Delegated Report		Analysis sheet		Expiry Date:	12/08/2020
		N/A / attached		Consultation Expiry Date:	24/08/2019
Officer			Application Number(s)		
Josh Lawlor			2020/1996/P		
Application Address			Drawing Numbers		
12 and 14 Northington Street London WC1N 2NW			See decision notice		
PO 3/4	Area Team Signature	C&UD	Authorised Officer Signature		
Proposal(s)					
Demolition of front facade, re-construction of front facade with metal panelling, bay windows with Juliet balconies at first floor and new fenestration at ground floor.					
Recommendation(s):		Refuse Planning Permission			
Application Type:		Full Planning Permission

Figure 1 existing elevation

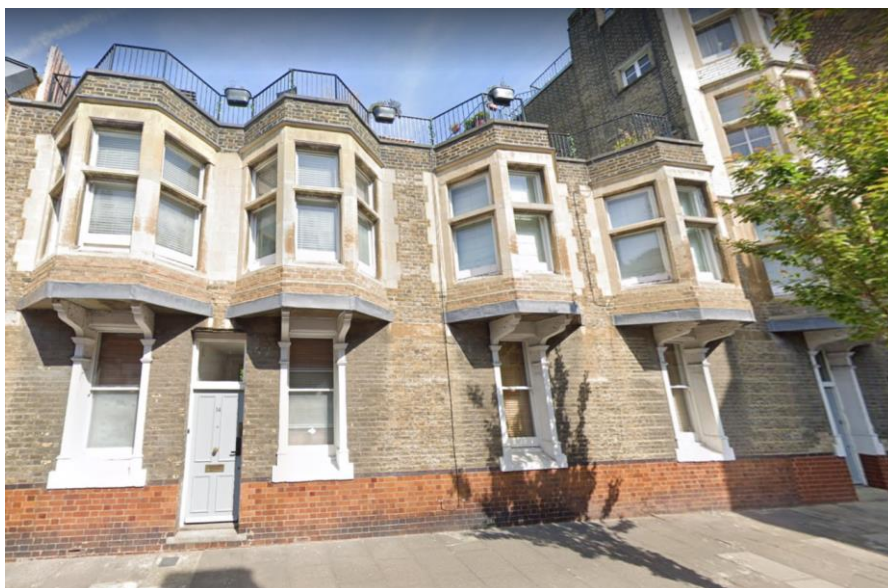
and appearance of the Bloomsbury Conservation Area. The facade is a fine example of early 20th century architecture, it is an interesting composition of various types of brick and stone with distinctive cantilevered oriel bays which contribute to this characterful part of the conservation area. The elevations are of architectural merit, and the building is considered to hold heritage value which should be preserved. The proposal would involve the demolition of all original surface materials on the elevation, destroying the integrity of the building and harming the character and appearance of the conservation area.

- 3.4. Notwithstanding the loss of an entire elevation that holds historic and architectural value, the proposed replacement elevation is of poor quality design which is out of keeping with the rest of the streetscene. The new design fails to respond to the local vernacular in terms of materials, textures, colours and architectural style. The new contemporary elevation would be incongruous to its surrounds. The new design would contrast harshly with the style of buildings in this part of the conservation area. The elevation does not respond to the surrounding architecture and character of the street scene. Indeed it appears little consideration has been made into how the design will integrate into its surrounding context. Indeed there are no references to details within the streetscene or wider conservation area. The metallic cladding will appear harsh against the brick and stone of surrounding buildings. The proposed full height windows lack crispness, finesse and clarity. The size of the windows do not relate to surrounding buildings. There is an excessive amount of glazing in relation to the amount of solid surface, there is no hierarchy to the window sizes. The projecting glazing at first floor appears too dominant. It is not clear if these materials would weather well, so their ageing process contributes positively to the character of the area, and the site's wider context.

- 3.5. Para 196 of the NPPF (2019) states that 'Where a development proposal will lead to less than substantial harm to the significance of a designated heritage asset, this harm should be weighed against the public benefits of the proposal including, where appropriate, securing its optimum viable use'. The proposal comprises complete demolition of the front façade of a building which makes a positive contribution to the character and appearance of the conservation area and a replacement façade of poor quality design. Therefore the proposal is considered to cause 'less than substantial harm' to the character, appearance and historic interest of the conservation area as well as to the host property. There is no demonstrable public benefit created as a result of the proposal.
